N-63-4-3

STANDARDIZATION OF COMPONENTS
FOR
CD V-700, CD V-715, CD V-727

BY
THE VICTOREEN INSTRUMENT COMPANY
CLEVELAND, OHIO

The following three lists are recommended changes in the CD V-700, CD V-715, and CD V-727 specifications. Practically all of the recommendations are allied directly with standardization, but a few are items which merely require updating because they have escaped notice. This section only lists the actual changes. Discussion of the reasons for these recommendations is given in later sections of this report:

THE VICTOREEN INSTRUMENT CO. INSTRUMENT DIV. CLEVELAND, OHIO	
CASE TOP	
MATERIAL DIE-CAST ALUM.	FINISH PAINT PER VICO SPEC. 7-12
DATE FULL MAR 12-27-62	815-103

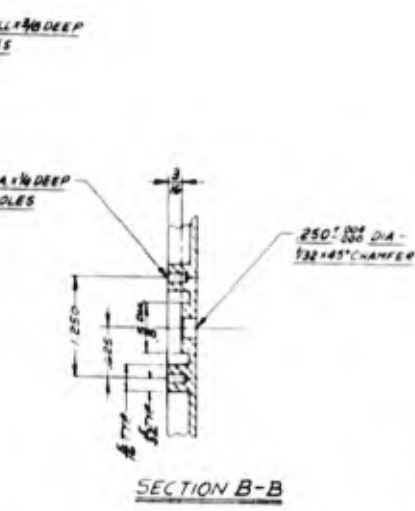
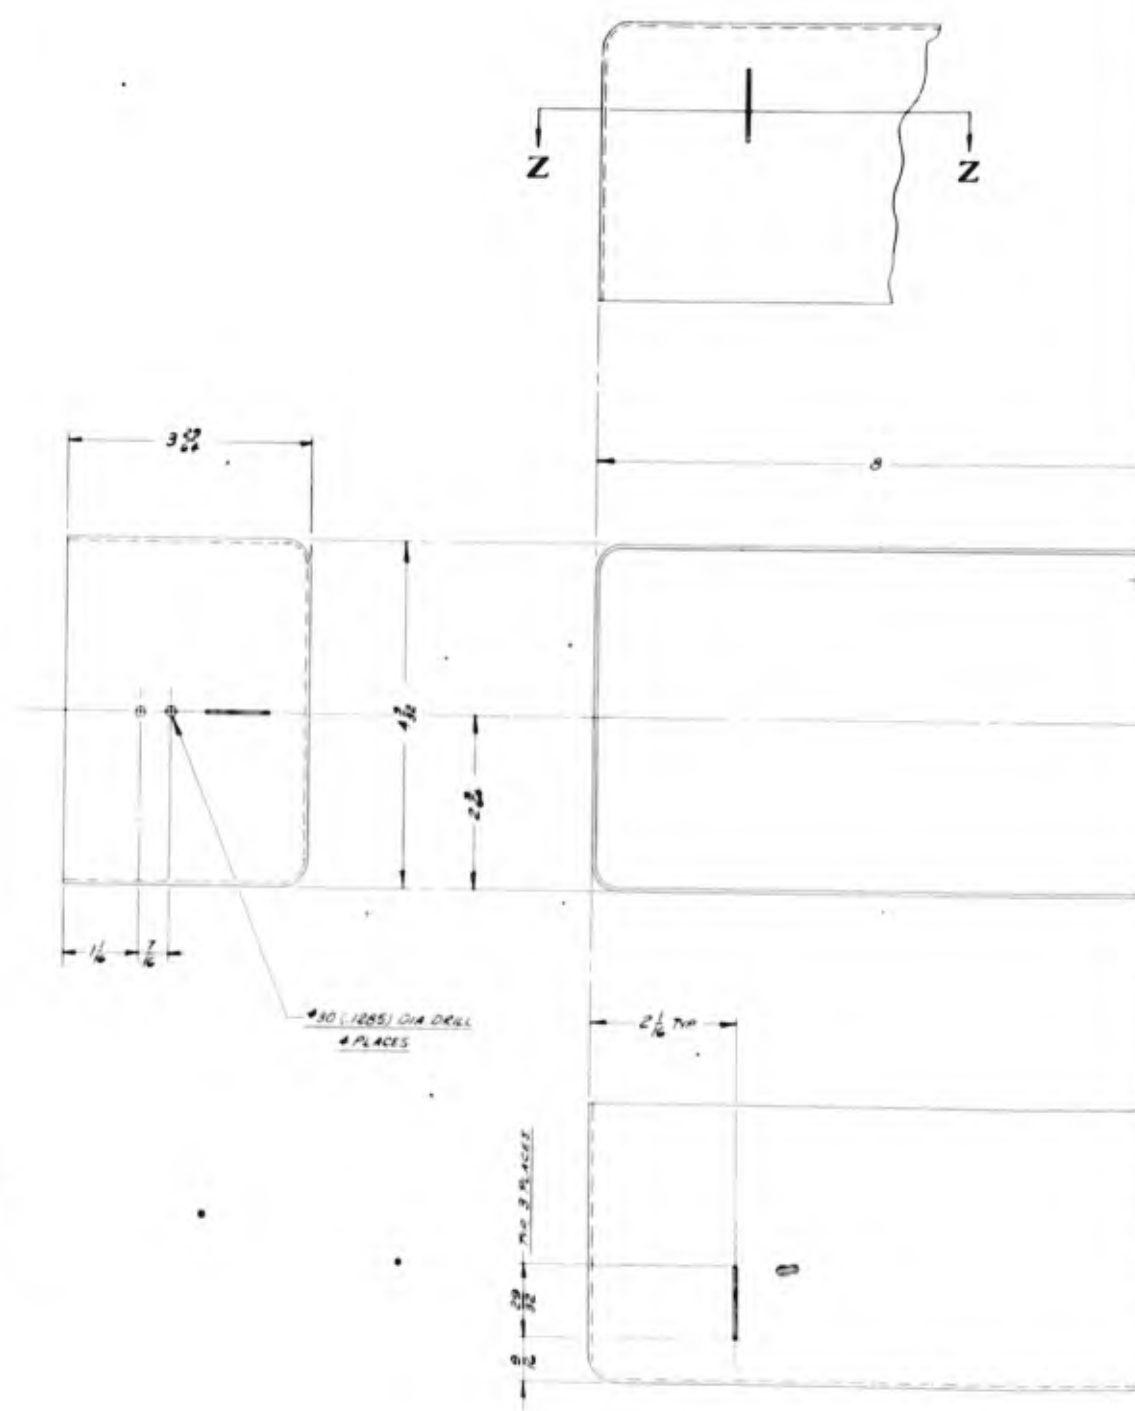
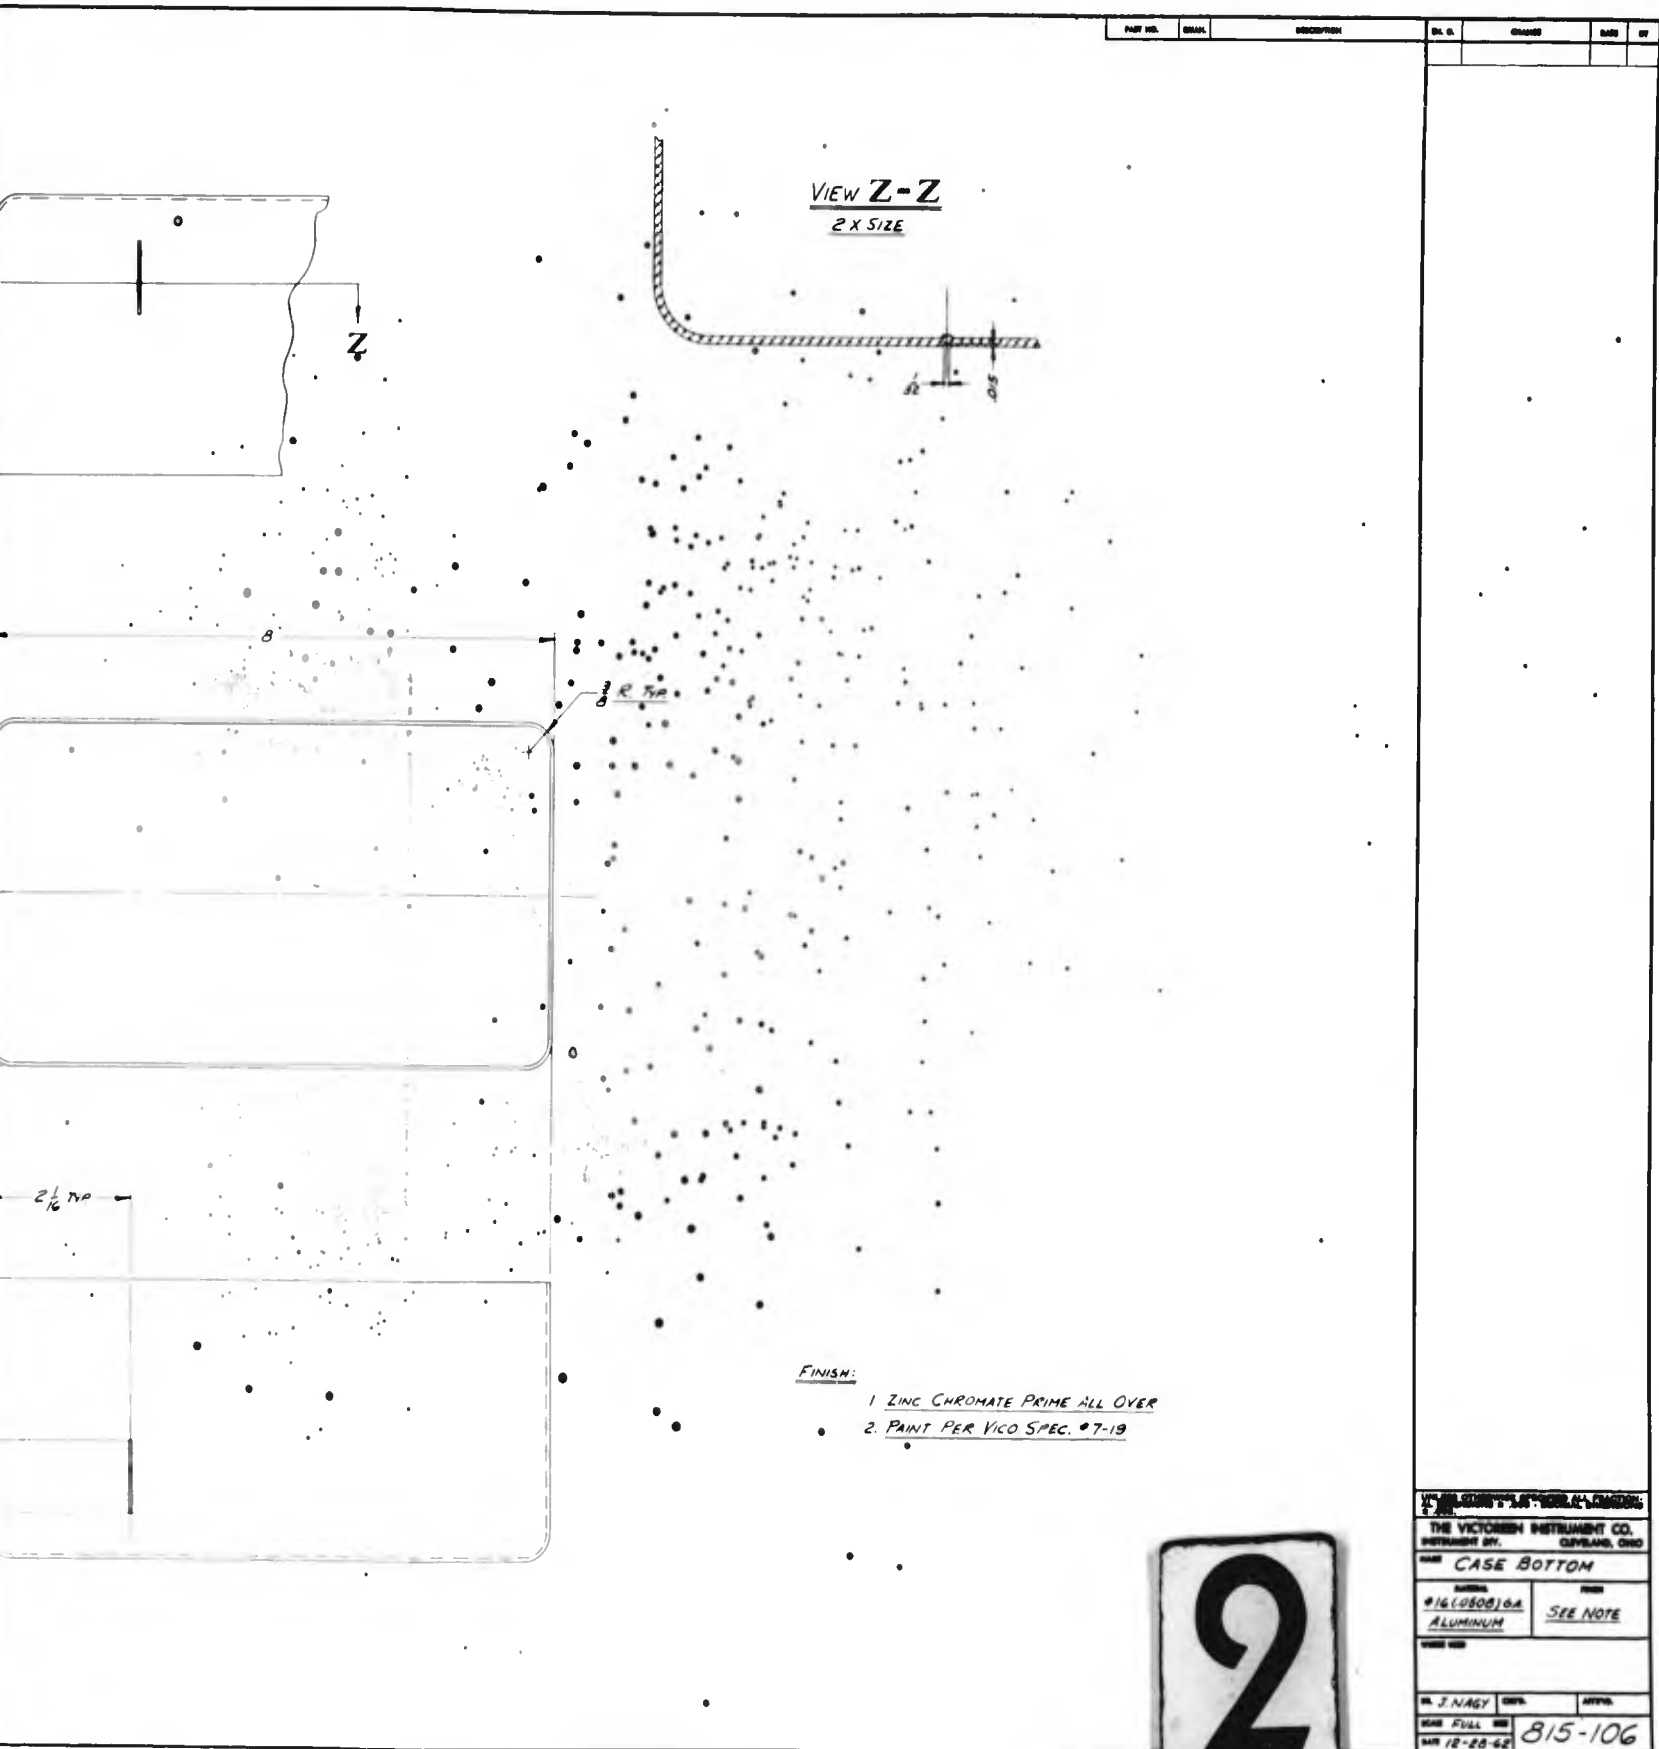
13. Attachment D. Replace page D-2 with drawing 815-103 (Figure 1 of this report). Replace page D-3 with drawing 700-214, battery box assembly, and details 700-209 and 700-210 (Figures 3, 4 and 5 of this report). Add as page D-6 the drawing 815-106, case bottom (Figure 2 of this report).

10. Attachment C. Substitute drawing 815-103 (Figure 1 of this report) for page

C-2. Add drawing 815-106, case bottom (Figure 2 of this report) as page C-3.

6. Attachment C-2. Replace with drawing 815-103 (Figure 1 of this report).

Because of the above, the standardized case top may not be used as a replacement part for all existing instrument models. However, the case bottom shown in Figure 2 may be so used. This figure calls for an aluminum bottom, but a drawn steel version with a slight flange is entirely adequate from the gamma-ray absorption consideration discussed later, as long as the dimensions of Figure 2 are not violated. The use of steel has therefore not been eliminated from the proposed specification.

It is felt important to point out that the dimensioning of the case top gasket groove has been changed. The location of the groove itself is the same, but decimal dimensions have been so placed that accumulative tolerances will not result to permit the position of this groove to wander excessively. These new decimal dimensions and the case bottom dimensions will allow any case bottom and top to be used interchangeably.

FIGURE 3

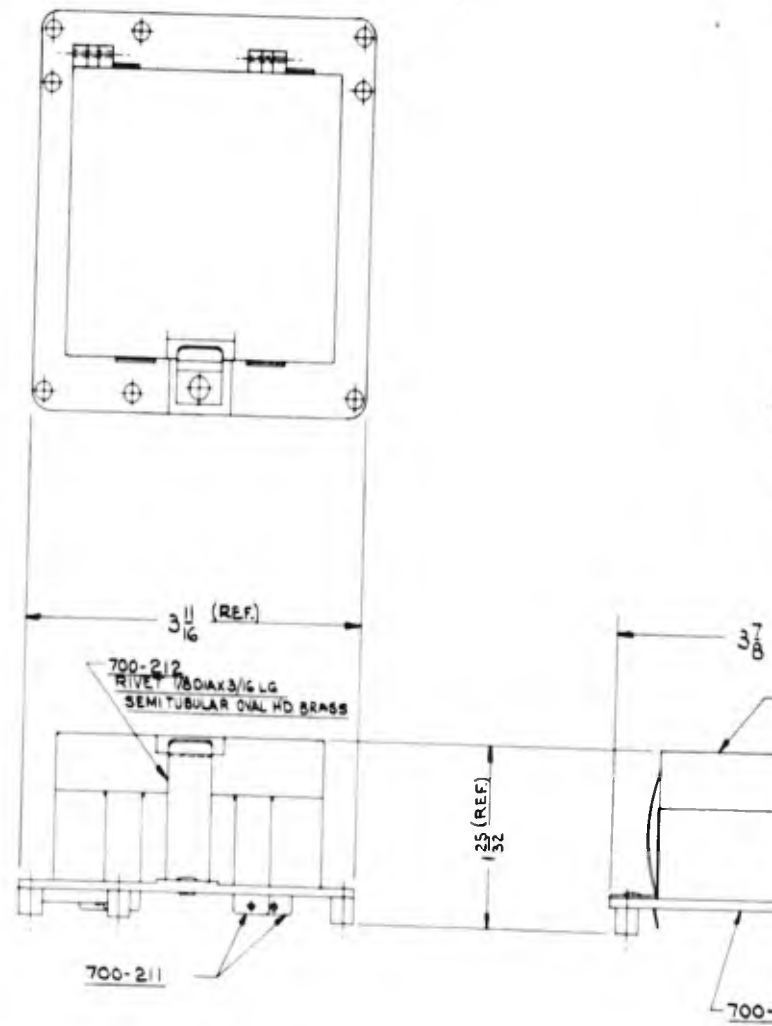
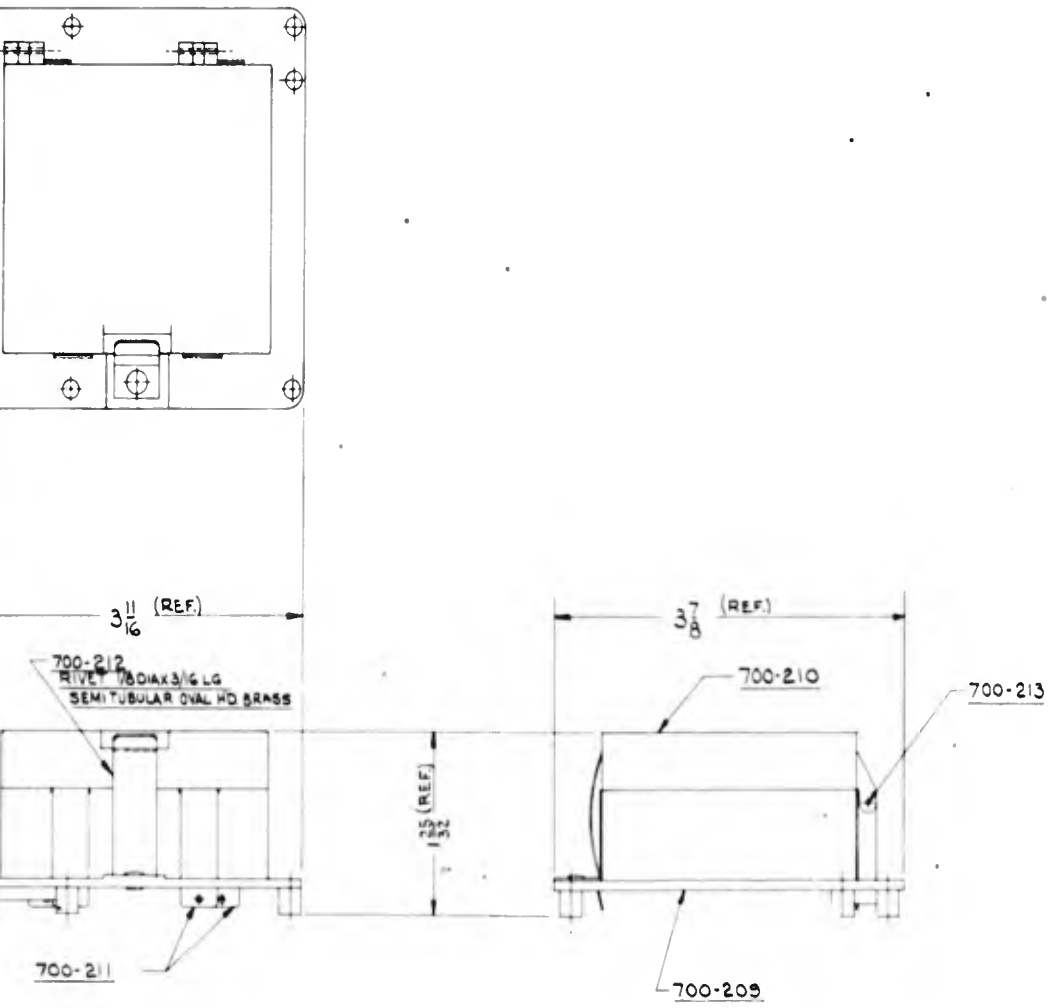
8. Attachment D-2. Replace battery box drawing with drawings 700-214, 700-209, 700-210, 815-100, 815-101, and 815-102 (Figures 3 thru 8 of this report).

The designs for the enclosed single and double battery boxes are shown in Figures 3 thru 8. Additional detail drawings of hinges and snaps which are referred to in these figures are provided in the drawings which cover the specification of the individual instrument parts. The battery boxes have mounting holes not only for the new standardized boss location, but also for the bosses of existing instrument types. In other words, these battery boxes may be used as spare parts or replacement parts for existing instrument models.

FIGURE 9

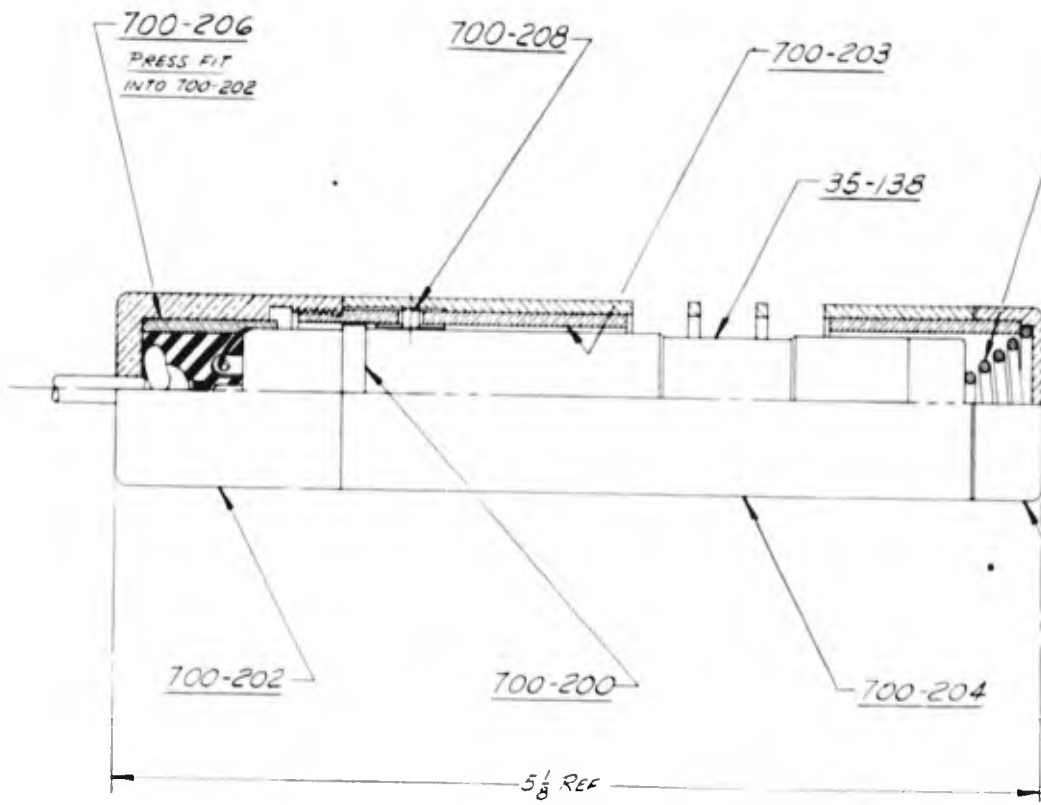
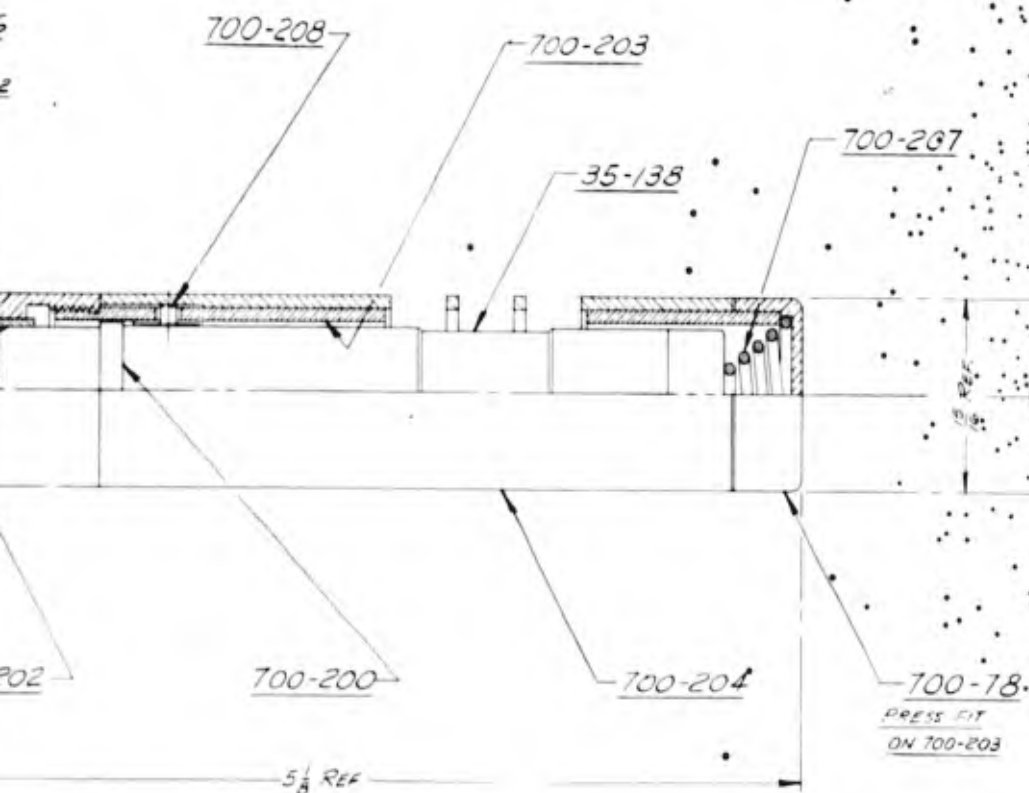
12. Attachment B. Replace drawing of page B-1 with drawing 700-205 of probe assembly and details 700-202, 700-203, 700-204 and 700-206 (Figures 9 thru 13 of this report).

The geiger tube probe drawings, Figures 9 thru 13, along with the changes of tolerance on the window location of the geiger tube makes for a uniform assembly in which the geiger tube window and the probe window will always line up properly. Figures 16 thru 21 show the complete developmental story. Figure 16 is the present specified geiger tube. Figure 17 shows the variations in window position possible. Figure 18 shows the result on the combination of probe and tube as presently specified and found in the prototypes. Figures

FIGURE 14

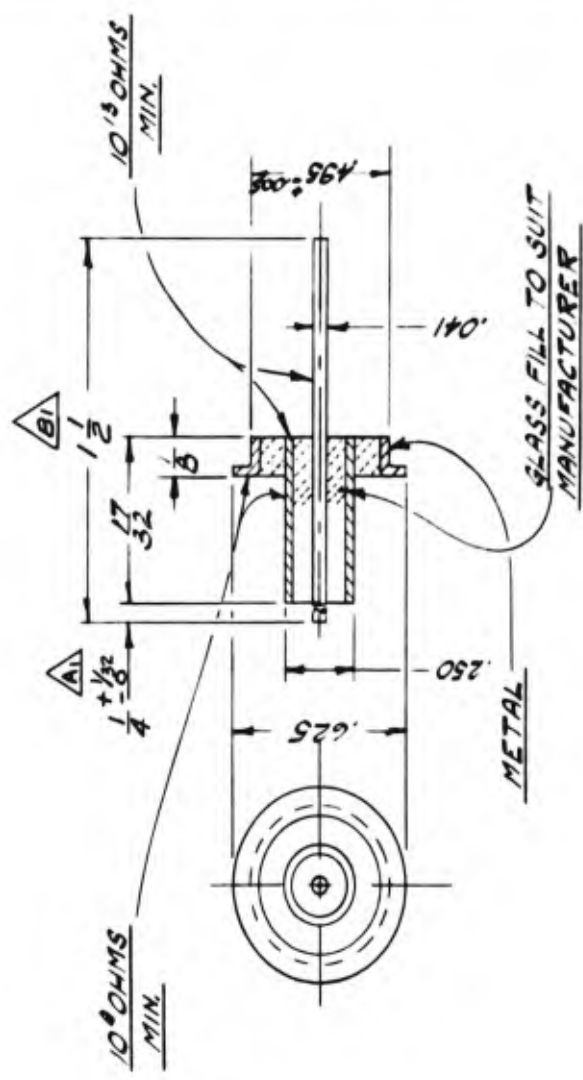
9. Attachment A. Add the drawings of the ion chamber parts submitted with the prototype instruments. As an alternate add drawing 815-12 of the feed-thru terminal (Figure 14 of this report) and a word description of the chamber parts as in the CD V-727 or CD V-717 specifications.
